# UNITED STATES PATENT AND TRADEMARK OFFICE

APPLICATION NO.	FILING DATE	FIRST NAMED INVENTOR	ATTORNEY DOCKET NO.	CONFIRMATION NO.
10/813,701	02/06/2003	Gilles Simard	5489-98"US"	4145

This is the **Final Office Action** for application number 10/813,701 Attachment Bracket for Shelf Support System, filed on 2/6/03. Claims 1-21 are pending. This **Final Office Action** is in response to applicant's reply dated 9/19/05. The text of those sections of Title 35, U.S. Code not included in this action can be found in a prior Office action.

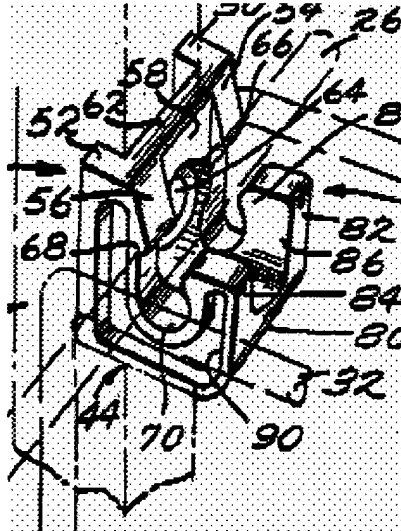
Claims 1-4, 8-11 and 15-18 are rejected under 35 U.S.C. 102(b) as being anticipated by United States Patent No. 4735325 to Remmers.

The patent to Remmers discloses an attachment bracket (42) having a back wall (62) defining a bottom, a top and vertical edges, and side arms (44), extending laterally from the vertical edges of the back wall, and a first and second protrusion (50, 52), located on the junction of the inner surfaces of the back wall of the bracket and wherein the inner surface of the side arms have a pimple (56) at a predetermined distance from the back wall. Remmers also teaches wherein the side arms have a slot (70) with friction edge portions (66, 68, 88).

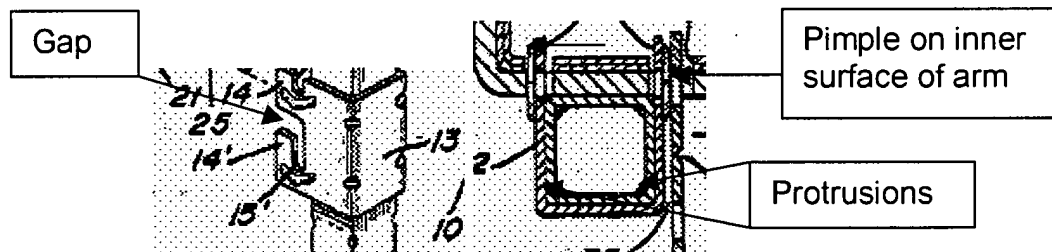
Claims 1, 5-8, 12-15 and 19-21 are rejected under 35 U.S.C. 103(a) as being unpatentable over United States Patent No. 4592286 to Trubiano, and in view of United States Patent No. 4735325 to Remmers.

Trubiano discloses applicant's basic inventive concept including an attachment bracket having a back wall (13) defining a bottom, a top and vertical edges, and side arms (14) extending laterally from the vertical edges of the back wall, first and second protrusions (See Drawing Below) located on the inner surfaces of the bracket and wherein the side arm has a pimple (See Figure Below) on an inner surface at a predetermined distance from the back wall, each of the side arms having an upper and lower slot (15, 15'), the upper slots being open on each arm. Trubiano also discloses wherein each of the side arms has a gap (See Drawing) open at a lateral edge thereof.

Trubiano does not teach wherein the slots have a friction edge portion.
